EPA Evaluation of the Dynamix Device Under Section 511  
of the Motor Vehicle Information and Cost Savings Act

August 1982

Test and Evaluation Branch  
Emission Control Technology Division  
Office of Mobile Sources  
U.S. Environmental Protection Agency

Figure 2 Proportioning Valve

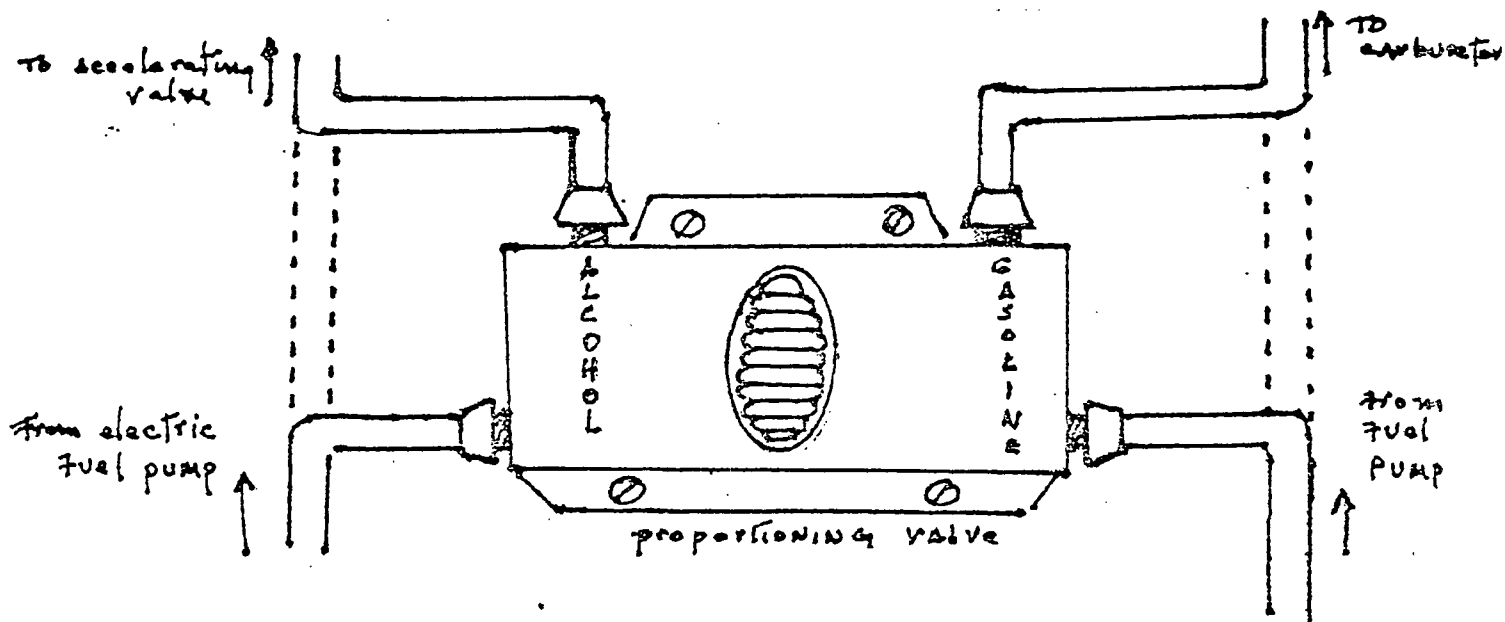
The description of the proportioning valve is not sufficient to show that it is actually able to function as claimed. The description does not specify how the device is able to control the flow of gasoline to be a fixed percentage (i.e., flow ratio) of the alcohol flow and how this flow ratio is readily adjustable by the operator.

- E. Details of the proportional valve and its controls are needed.
  - F. The device appears to restrict the flow of gasoline to a set percentage of the alcohol being consumed. It appears that under most driving conditions, the carburetor float bowl will not be full and in fact may be relatively empty. If this is correct,

- B. The drawings of the proportioning valve, provided as an attachment to your letter, do not adequately describe the valve and its manner of operation. Please provide a more detailed description of the valve and its method of controlling the flows of ethanol and gasoline.

- 2D. Your observation is correct, the alcohol flow is controlled by the accelerating valve, after maximum proportions are preset by the proportioning valve.

Figure 3 Accelerator Valve and Linkage

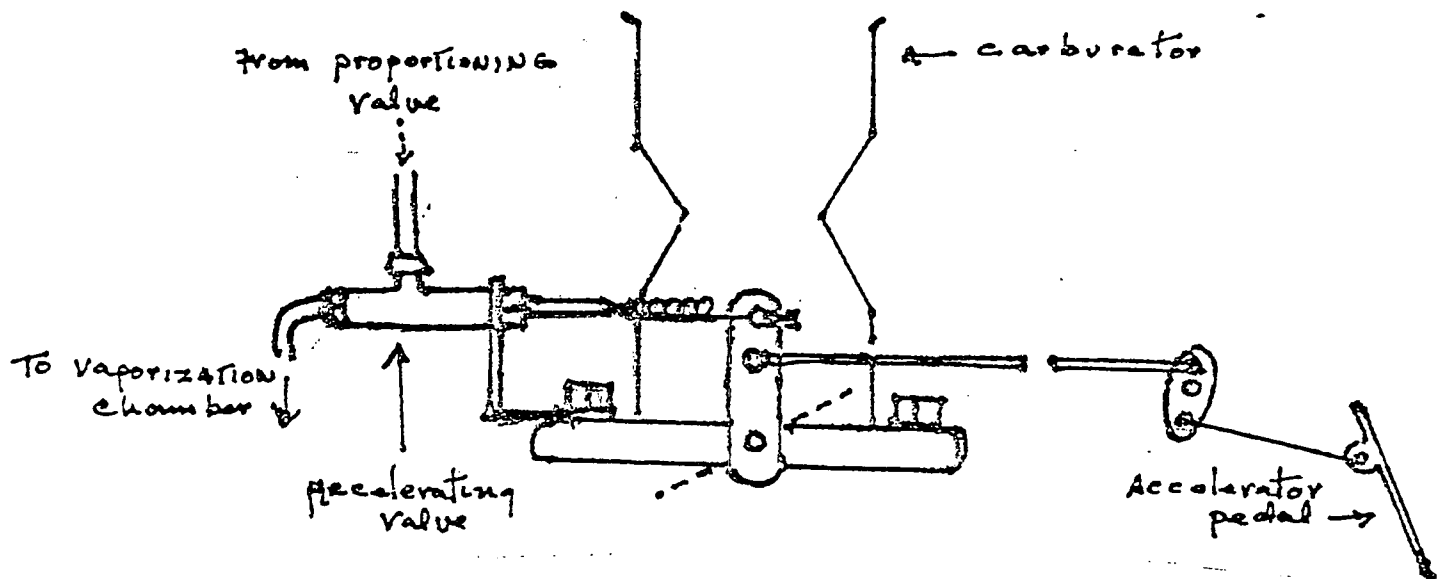
The description of the "accelerating valve" was also inadequate. Although it was called an accelerating valve, it appears to be more properly an alcohol flow control valve that is opened and closed by the throttle linkage. It does not replace the function of the carburetor accelerator pump. The functioning of this valve is also questionable. The linkage adjustment procedures instruct the installer to adjust this valve so that it is shut off at idle and is open at engine red-line (while in gear) sufficiently to control the alcohol flow to be the desired alcohol/gasoline fuel ratio. Therefore, the alcohol flow is controlled to be a function of throttle position only, regardless of engine load, whereas, in an unmodified engine, gasoline flow is controlled to be a function of both load and rpm. Thus the engine could have either too much or too little of this gasoline/alcohol blend under all operating conditions.

An additional problem is that the normal supplemental carburetor circuits (idle, accelerator pump, and power enrichment) probably will not function normally due to the reduced flow of gasoline and air into the carburetor. The device appears to have no means to incorporate these necessary auxiliary carburetor functions into the alcohol system. The applicant did not respond to EPA's requests (Attachment D & F) for this additional information.

- C. Your reply (2F) stated "However, quick and easy accelerating valve ...". I presume the accelerating valve here referred to is the alcohol accelerating valve. Is this assumption correct? The function of this accelerating valve appears to be to replace part of the engine's basic fuel requirement. Since the normal supplemental carburetor circuits (idle, accelerator pump, and power enrichment) probably will not function normally due to the reduced flow of gasoline and air into the carburetor, how are these supplemental functions performed by the alcohol accelerating valve.

Figure 4 Vaporization Chamber

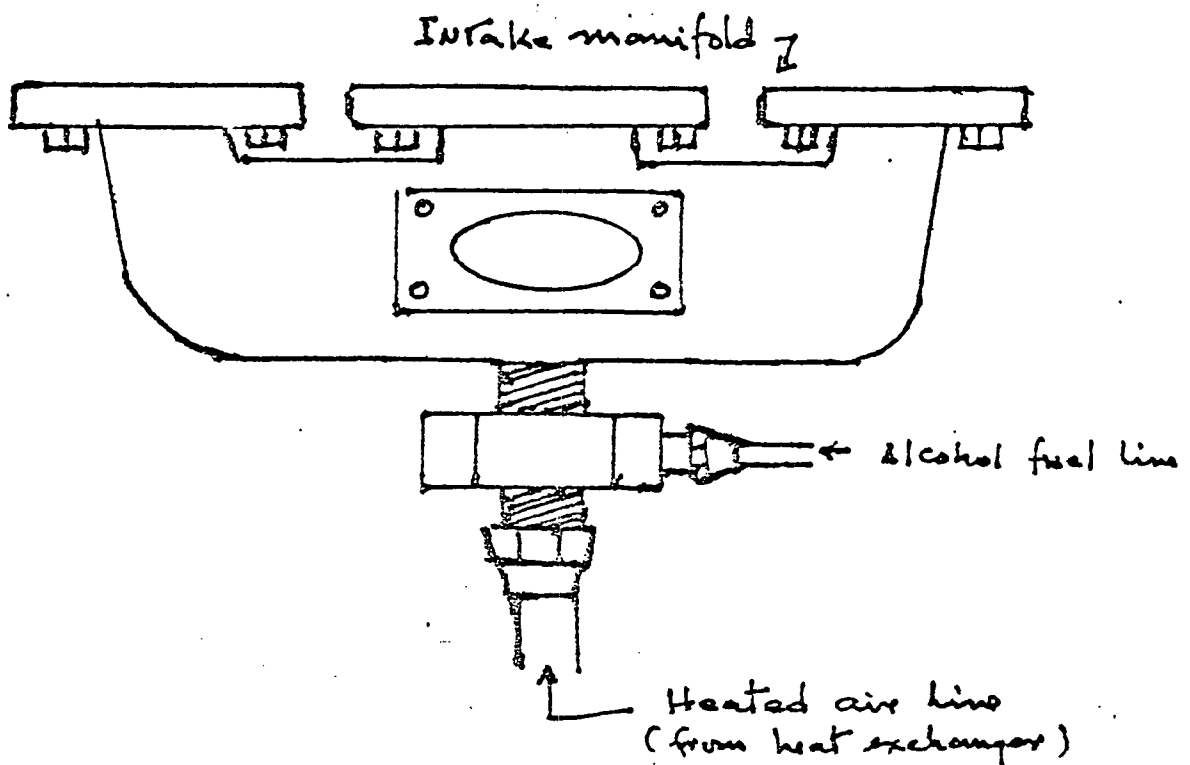
The vaporized alcohol is introduced at any convenient hole in the intake manifold. This will cause uneven fuel distribution to the various cylinders if either the hole is not centrally located or there is uneven mixing of the vaporized alcohol and gasoline. EPA asked the applicant to comment on this mixing problem (Attachment D). The applicant's response indicated that he was aware of the problem and now uses a carburetor base plate adapter to allow the vaporized alcohol to be introduced at the center of the intake manifold (Attachment E). This approach will tend to make the fuel mixture more uniform. However, the applicant submitted no information that showed that good mixing and distribution actually occurred.

3. Section IX, F. shows the vaporization chamber located in any convenient orifice in the intake manifold or the manifold PCV hole. It appears that this would not give an identical homogenous mixture of air, hydrous alcohol and gasoline to each cylinder for most vehicles. Please comment and provide data.
4. Section X, I. states that for adjusting the device and vehicle, the gasoline flowrate is taken "at a point just below the red-line of the tachometer while the vehicle is in motion". This adjustment procedure is unacceptable. It would require the vehicle to be operated at maximum speed for an extended period and thus present a safety hazard.

3. You must be referring to the need to effect a fairly equal distribution of air and fuel alcohol to all the cylinders. This is not a problem when the orifice is located in the center of the intake manifold. Most of the popularly sold cars in the PHILIPPINES (RP) have the orifice in the center of the intake manifold. Whenever the orifice in the intake manifold is not centered, we provide an adapter immediately under the carburetor containing an inlet orifice for the device to effect a more equal distribution of fuel alcohol and heated air to all the cylinders.
